Opel

Astra G / Astra H

Recirculated air flap is not working

Bulletin

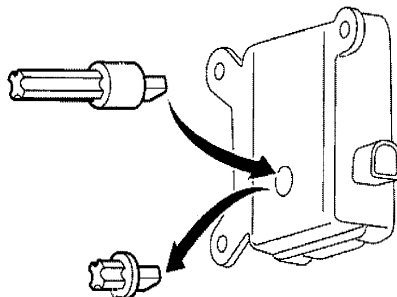
With the above-mentioned vehicles, a damaged shaft can lead to a malfunction of the recirculated air flap.

To remedy the situation, a modified recirculated air flap housing has to be installed. To do this, remove the short shaft in the recirculation flap motor and mount the long shaft included with the modified housing (see drawing). After conversion, a basic setting or functional test should be carried out.

Modified housing with end stops were used in product from the following VIN onwards:
